AMENDMENT OF SOLICITATION/MODIFICATION OF CONTRACT			1. CONTRACT ID CODE	PAGE OF PAGES 4
2. AMENDMENT/MODIFICATION NO. AM-0001	3. EFFECTIVE DATE 06/7/01	4. REQUISITION/PURCHASE REQ. NO.	5. PROJECT NO. (If applicable)	
6. ISSUED BY CODE	7. ADMINISTERED BY (If other than Item 6) CODE			
US ARMY ENGINEER DISTRICT, HONOLULU CORPS OF ENGINEERS, BUILDING S-200 FORT SHAFTER, HAWAII 96858-5440 CONTRACT SPECIALIST: RENEE M. HICKS

14. DESCRIPTION OF AMENDMENT/MODIFICATION (Organized by UCF section headings, including solicitation/contract subject matter where feasible.)
FY01 MCP KNMD983001, UPGRADE HANGAR COMPLEX, HICKAM AIR FORCE BASE, OAHU, HAWAII

- B. REVISED SECTIONS OF THE DRAWINGS (ISSUED AS SKETCHES): Following are revisions made to the drawings listed. They are provided with this amendment as sketches. These revised drawings will not be issued with this amendment but will be furnished to the successful bidder at the time of award of the contract.

SKM-3

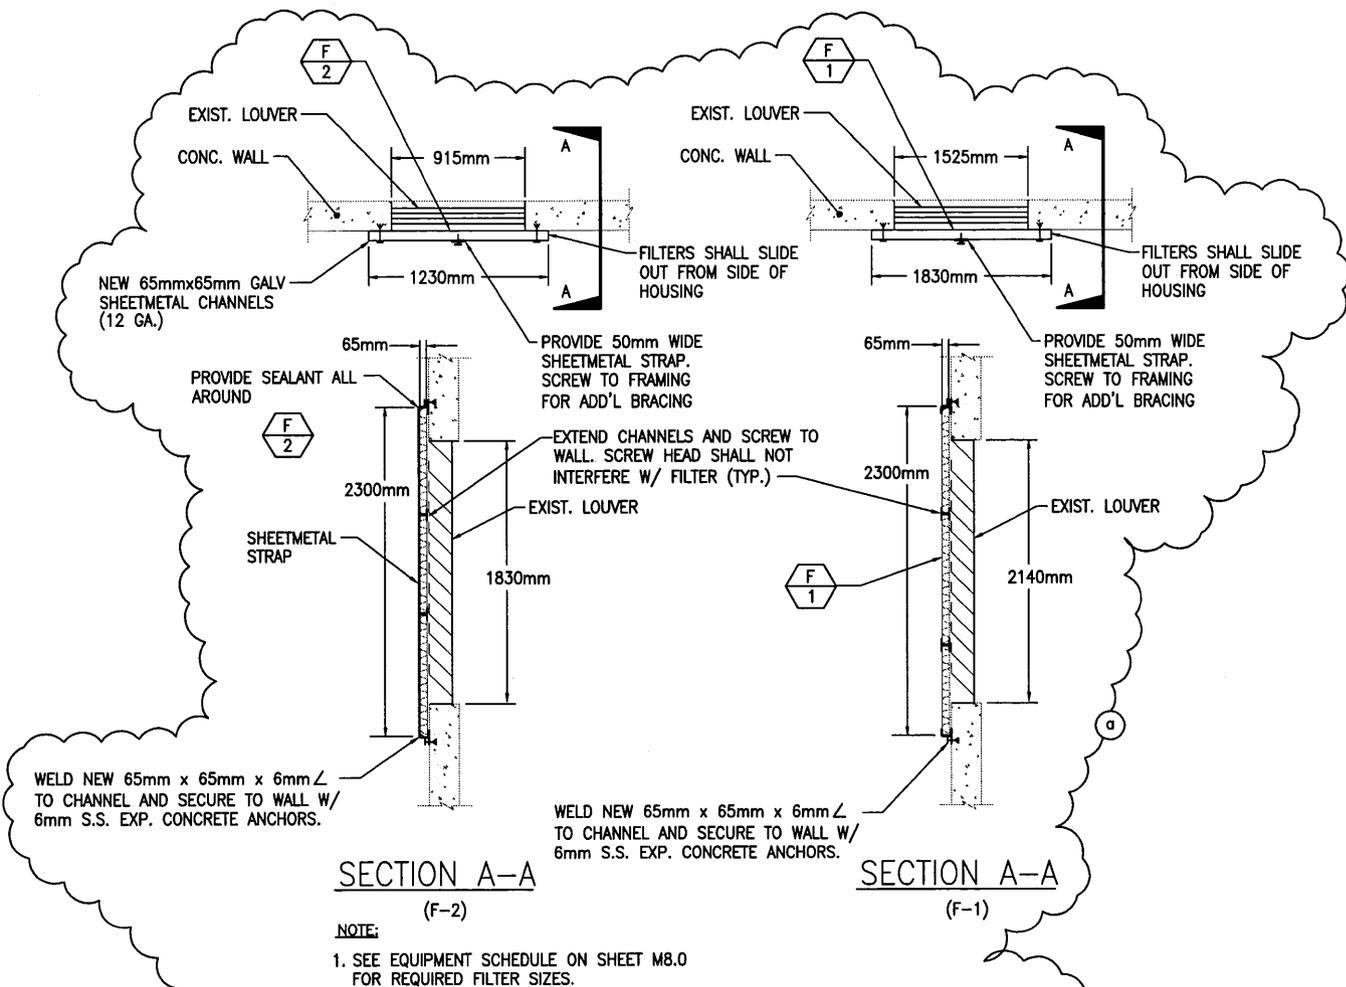
4
M2.3 | M2.15 NOT TO SCALE
TYP. EXHAUST FAN DETAIL

NOTE:
1. SEE EQUIPMENT SCHEDULE ON SHEET M8.0 FOR REQUIRED FILTER SIZES.

REFERENCE SHEET: M8.0 (ZONES B3,C3,D3)

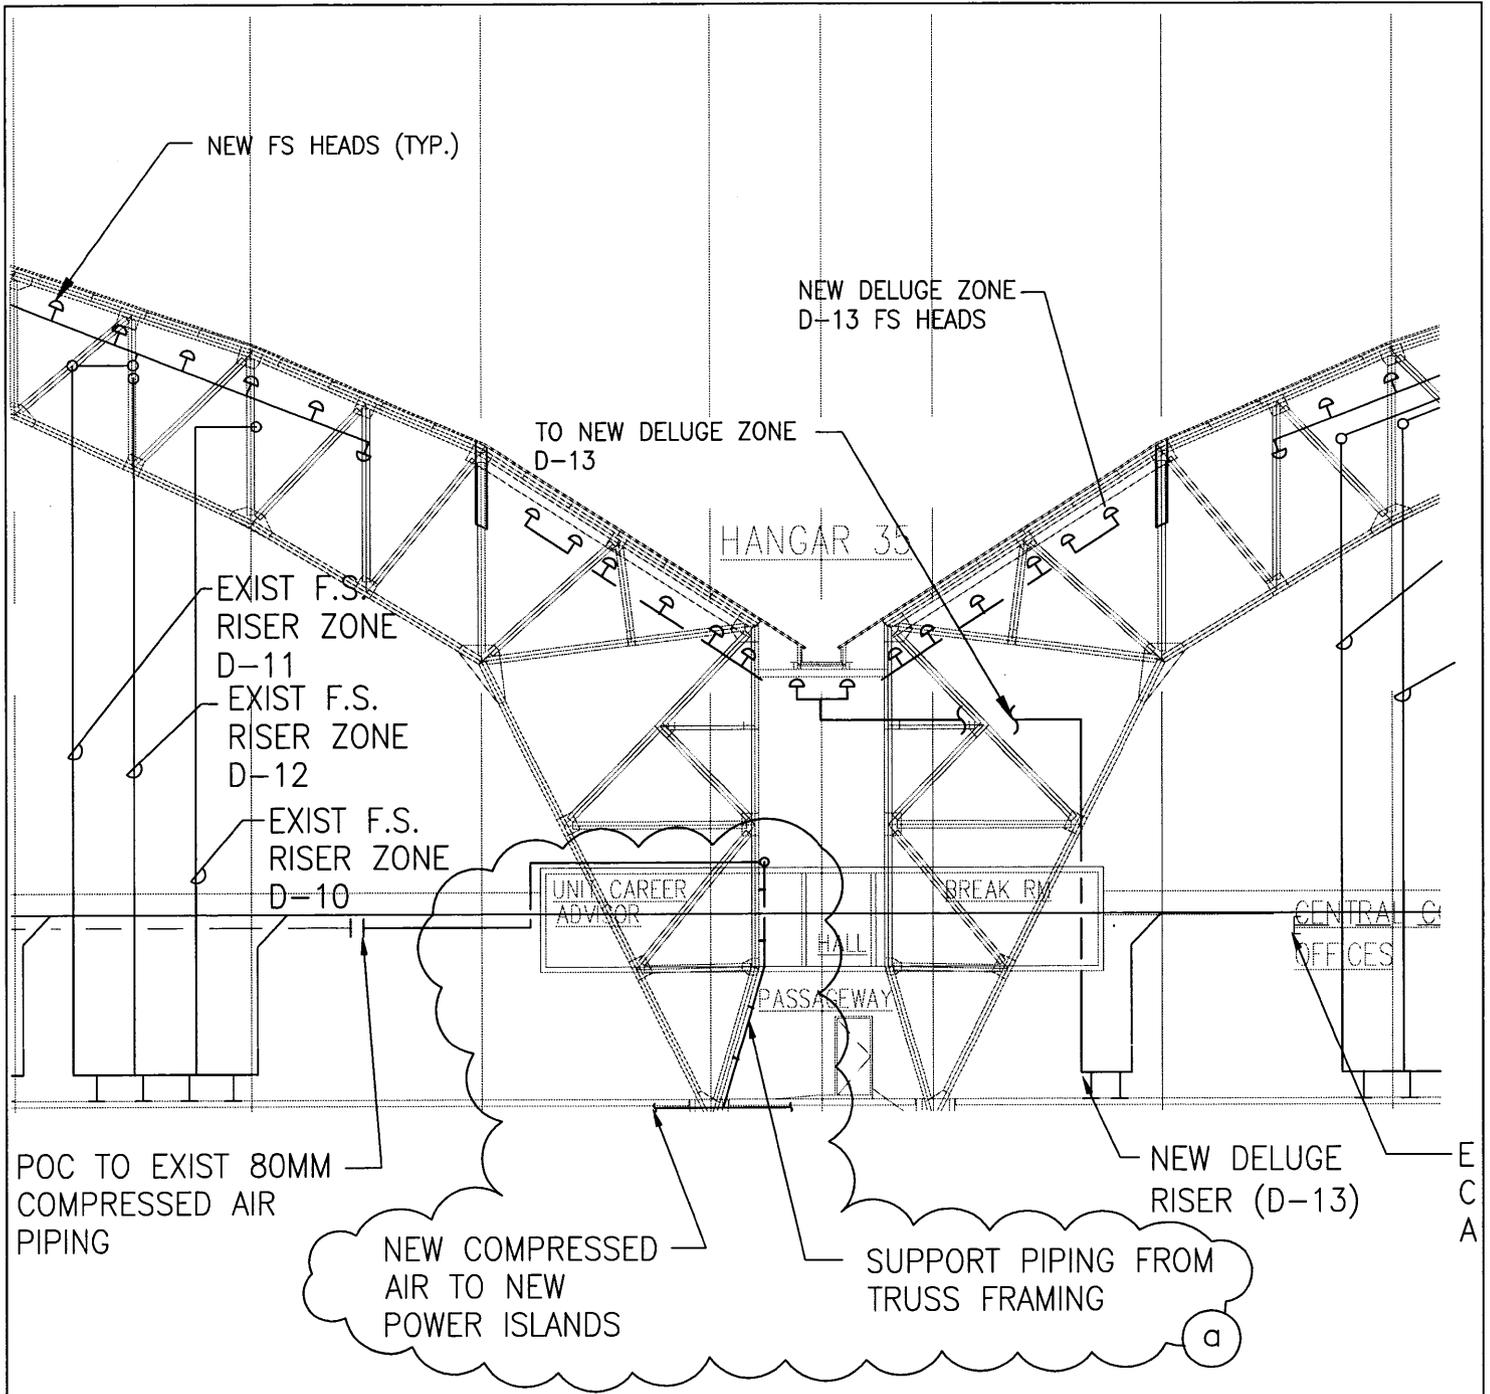
ST-D-18	40	3500	220	1300	75	H ₂ O	1380	900	400
ST-D-19	10	3500	220	500	75	H ₂ O	1380	900	400
ST-D-20	10	3500	220	500	75	H ₂ O	1380	900	400
ST-D-21	10	3500	220	500	75	H ₂ O	1380	900	400
ST-D-22	40	3500	220	1300	75	H ₂ O	1380	900	400
ST-D-23	10	3500	220	500	75	H ₂ O	1380	900	400
ST-D-24	30	3500	220	760	75	H ₂ O	1380	900	400
ST-D-25	10	3500	220	500	75	H ₂ O	1380	900	400

A
HANGAR 35 SECTION A
 M5.2 | M6.0 SCALE: 1:150

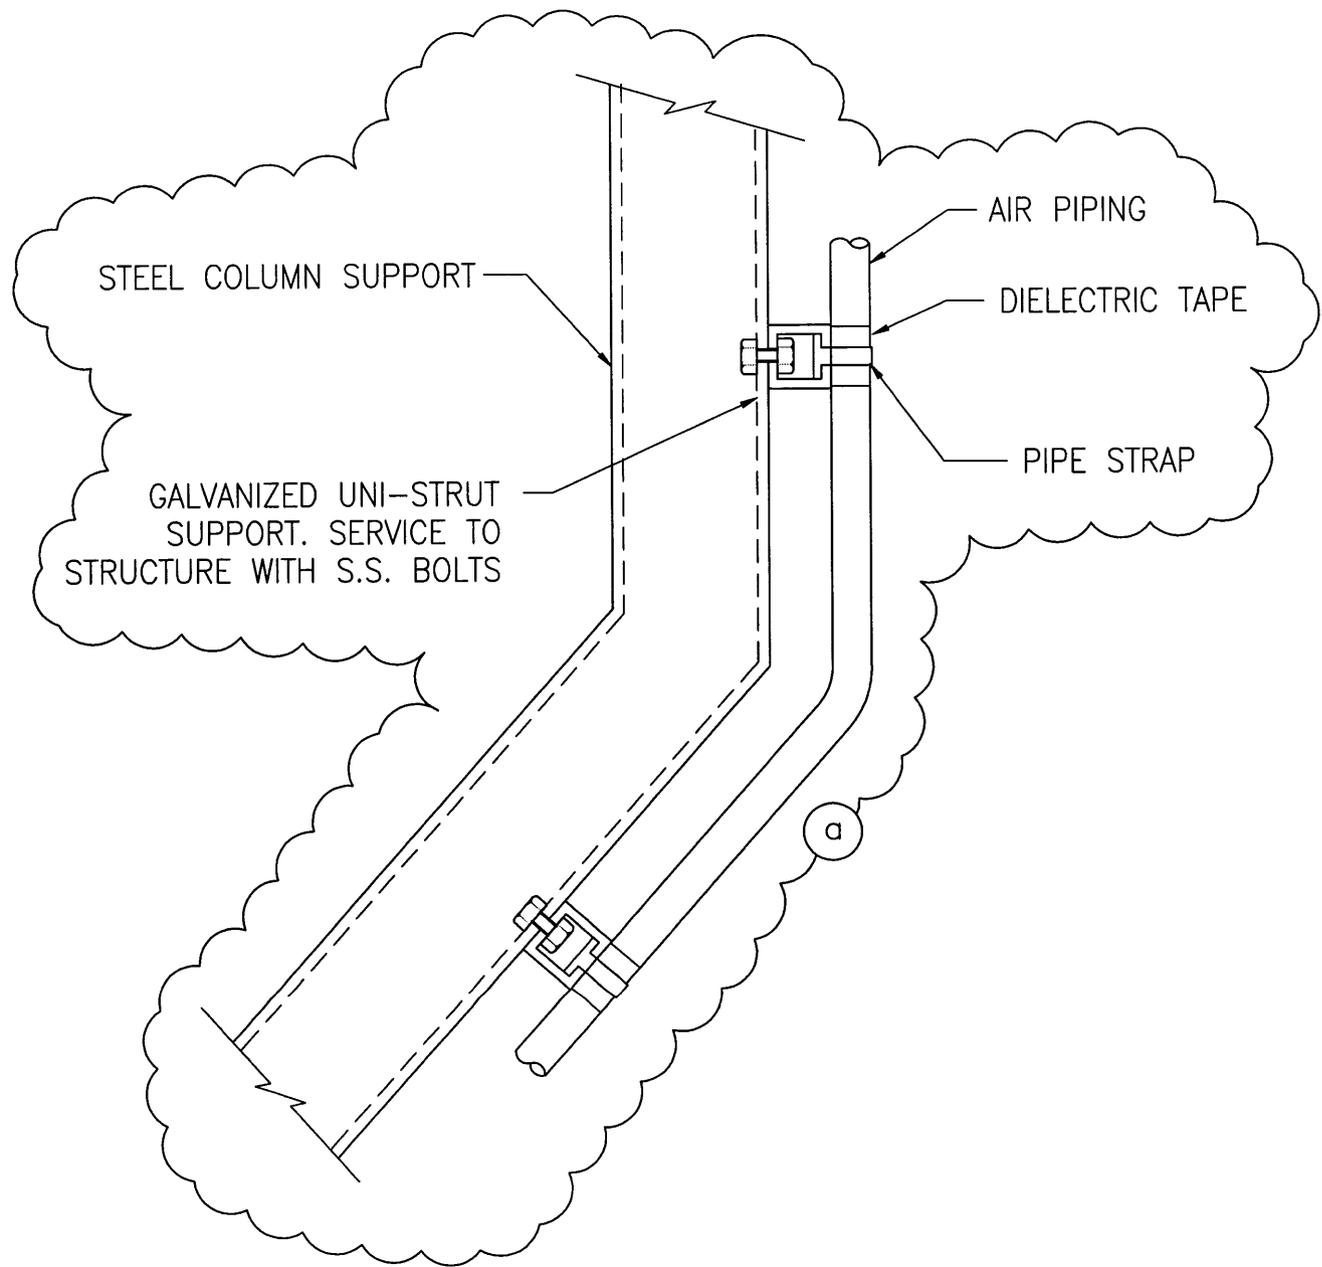
<u>SKETCH NO.</u>	<u>DWG.NO.</u>	<u>SHEET NO.</u>	<u>RING NO.</u>	<u>REV. LTR.</u>	<u>REV. DATE</u>
SKM-1	211-12-05	T1.0	1	A	25 May 01
Am-0001: DELETED note #9 from general notes.					
SKM-2	211-12-05	M5.2	105	A	25 May 01
Am-0001: ADDED location of trouble alarm panel for trap pit sump pumps.					
SKM-3	211-12-05	M5.2	105	A	25 May 01
Am-0001: ADDED note regarding cable/air hoses					
SKM-4	211-12-05	M2.15	84	A	25 May 01
Am-0001: REVISED detail 7/M2.15.					
SKM-5	211-12-05	M8.0	119	A	25 May 01
Am-0001: REVISED Deluge riser Surge Arrestor Schedule.					
SKM-6	211-12-05	M6.0	106	A	25 May 01
Am-0001: REVISED Hangar Section to show compressed air piping.

REFERENCE SHEET: M7.5 (ZONES C4,C5)

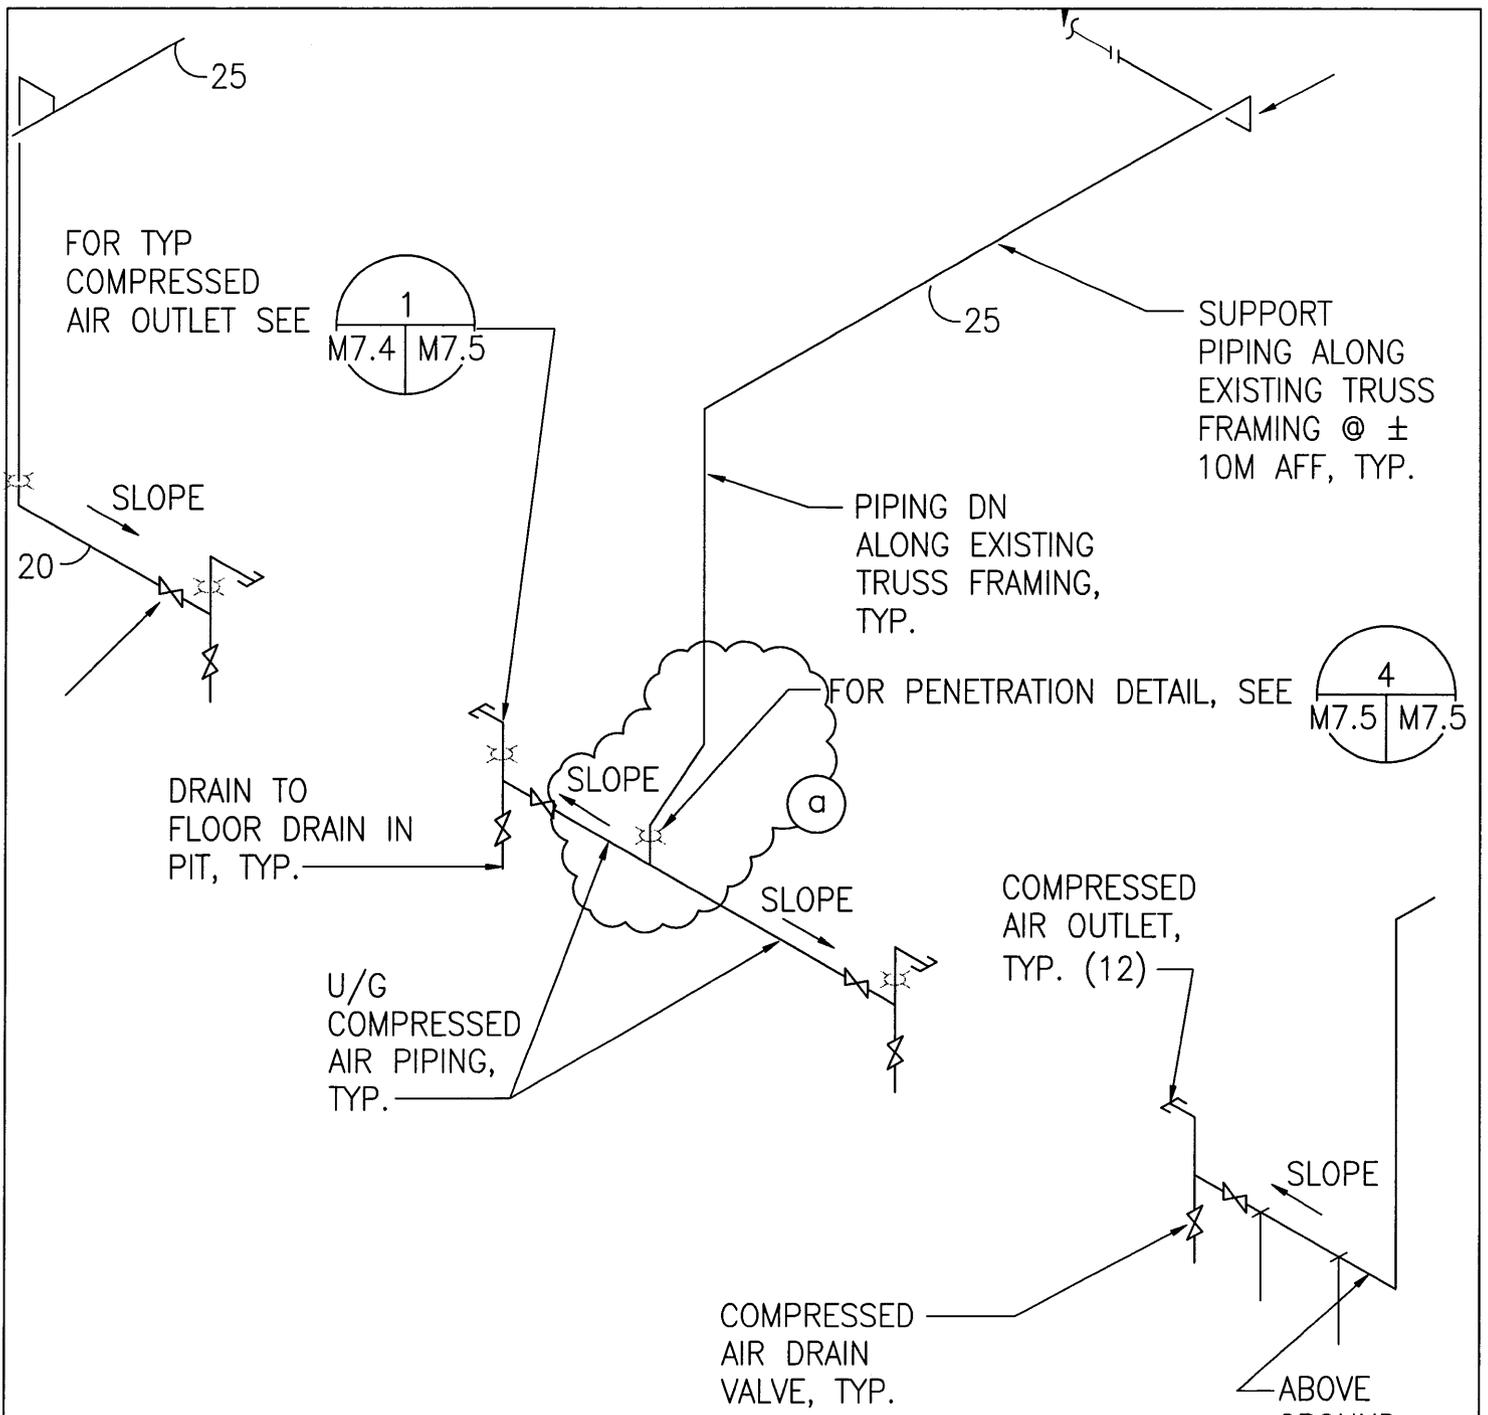
SKM-8 211-12-05 M7.5 118 A 25 May 01
AM-0001: REVISED compressed air piping diagram
